A d d e n d u m

Iowa Department of Transportation

B.O.	Proposal ID	Proposal Work Type	County	Project Number	Addendum
011	78-0293-069	BRIDGE REPLACEMENT - STEEL GIRDER	POTTAWATTAMIE	IM-NHS-029-3(69)53--03-78	20JUN011A03

Replaces plan sheets 2, 25, 26, J.01, and J.69 with the attached:

SHEET NUMBER 2

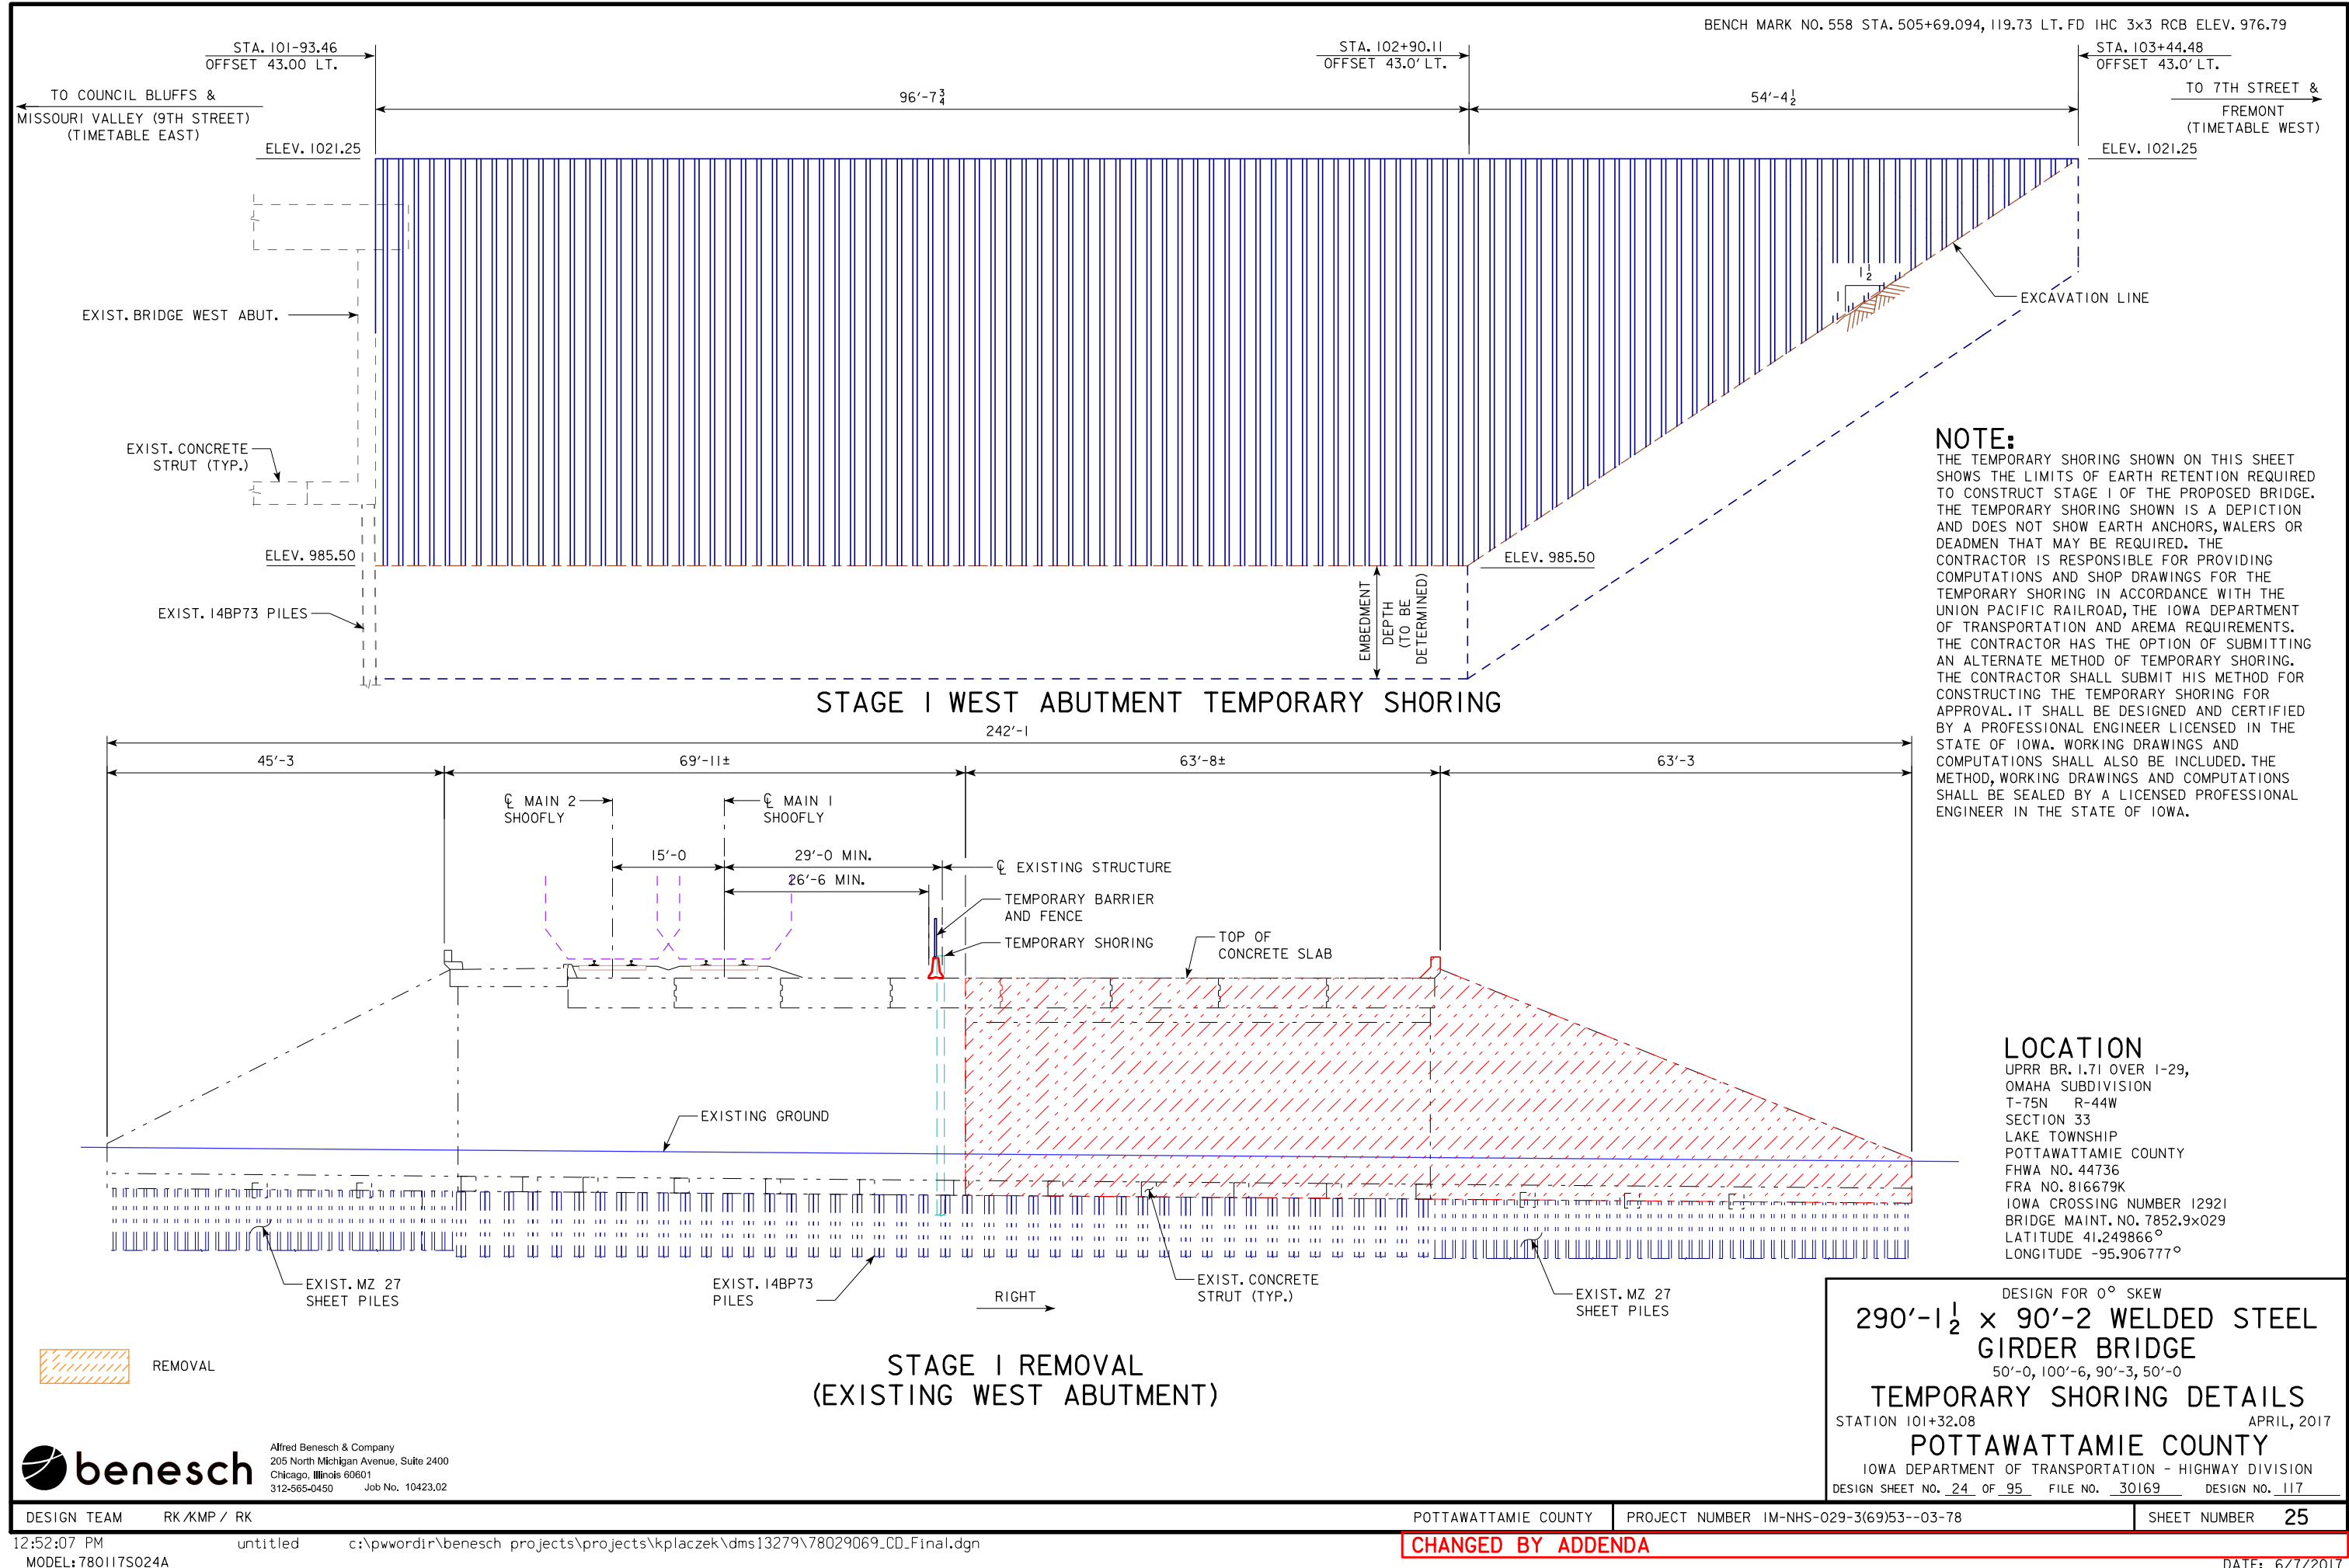
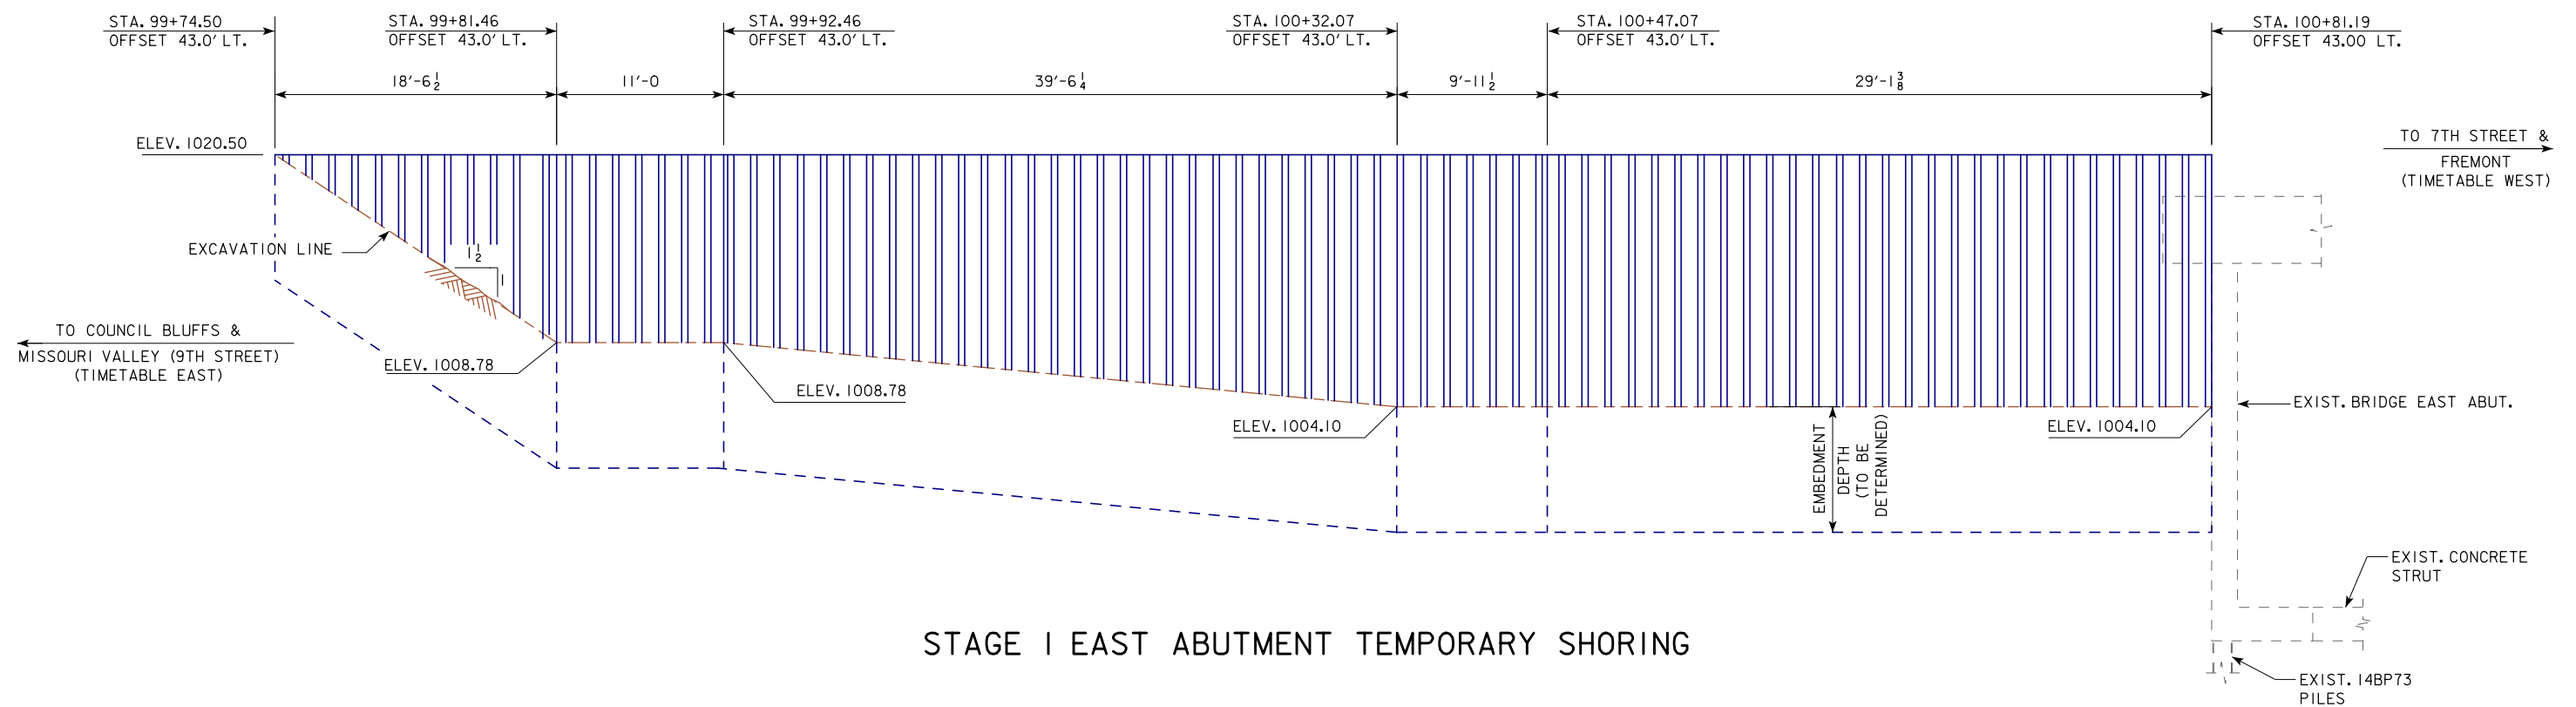
Sheet 2 – The exposed height of Stage 1 Temporary Shoring for the West Abutment was changed from 1,355 SFT to 1,434 SFT for Item No. 12 under the Estimate Reference Information

DESIGN FOR 0° SKEW
290'-1 $\frac{1}{2}$ x 90'-2 WELDED STEEL GIRDER BRIDGE
50'-0, 100'-6, 90'-3, 50'-0
TEMPORARY SHORING DETAILS
STATION 101+32.08 APRIL, 2017
POTTAWATTAMIE COUNTY
IOWA DEPARTMENT OF TRANSPORTATION - HIGHWAY DIVISION
DESIGN SHEET NO. 25 OF 95 FILE NO. 30169 DESIGN NO. 117

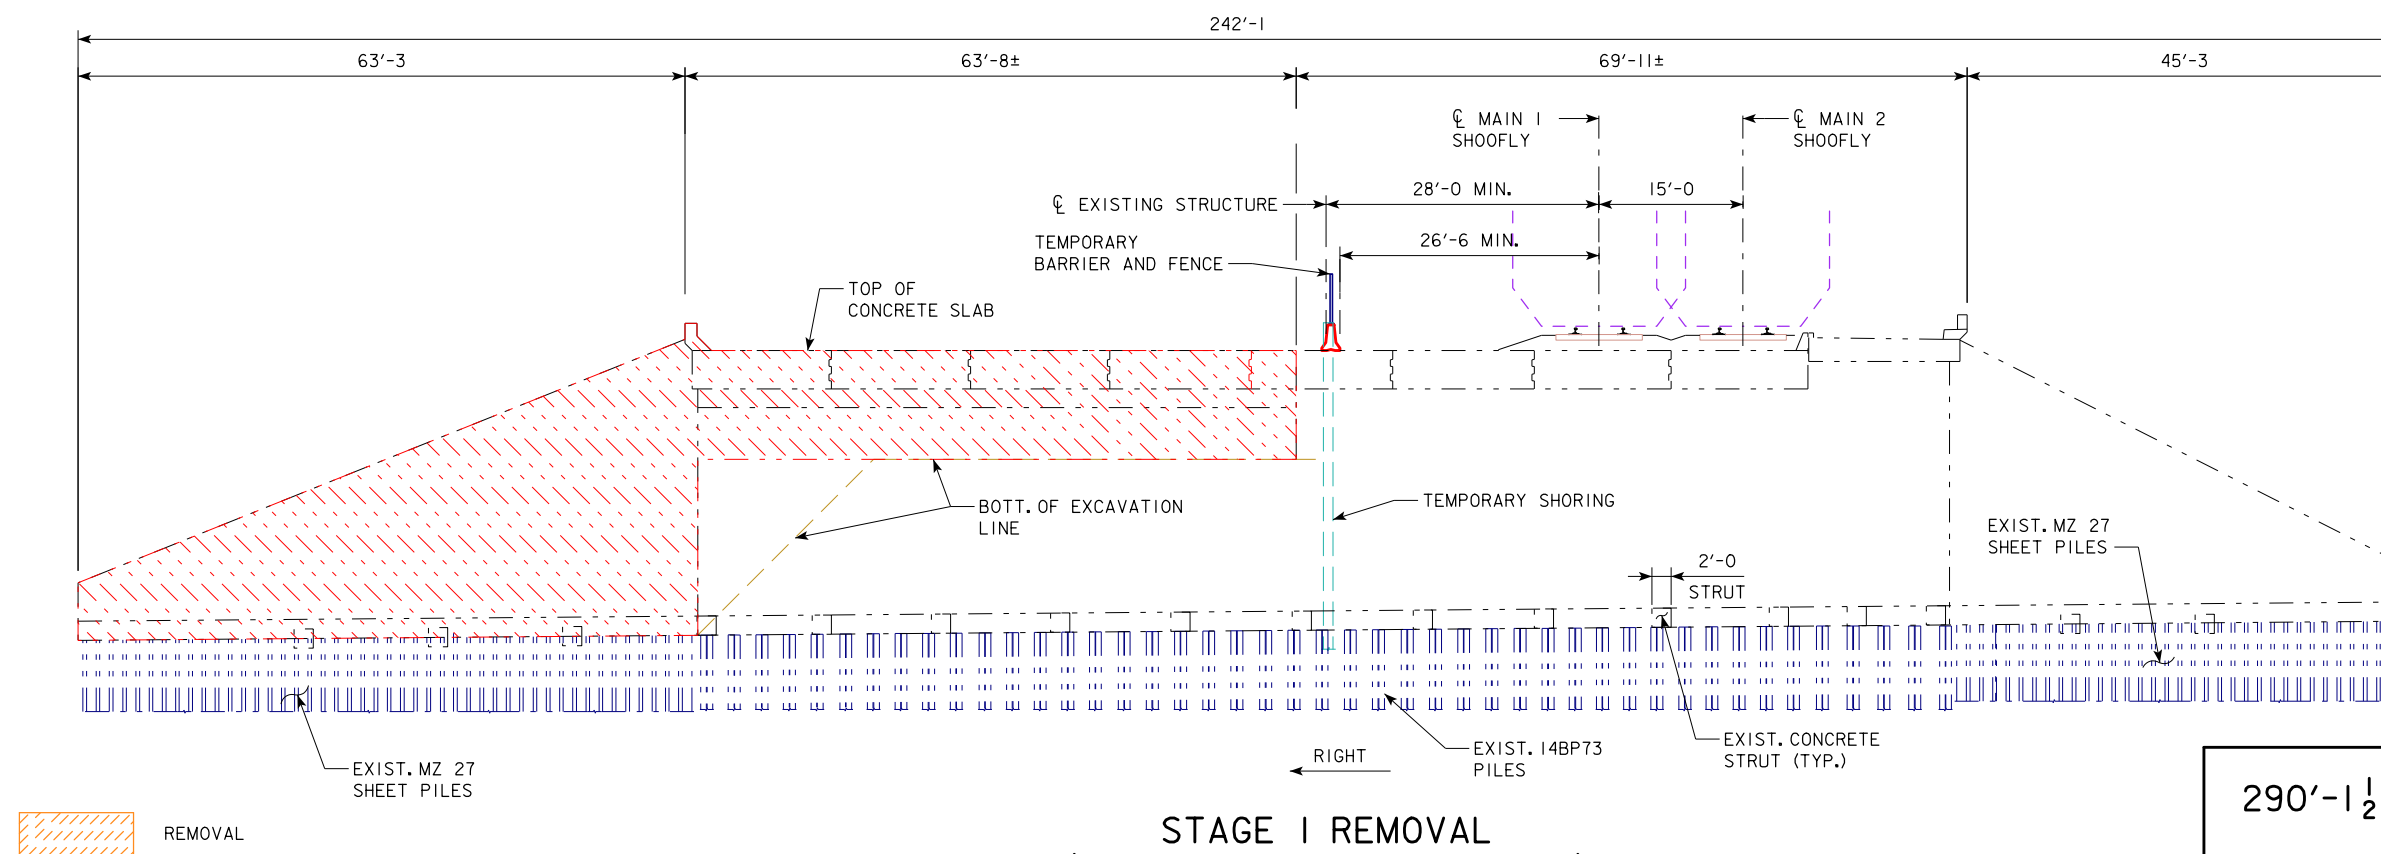
Sheet 25 – The number of tracks shown in the cross section STAGE 1 REMOVAL was revised from 3 tracks to 2 tracks.

12. Plan Sheet Number 25 and 26 will be updated by Benesch showing 2 temporary tracks.
13. Project Site Visit notes:
 - a. How many Trains per day does this site average? Answer: 18 to 25 trains per day.
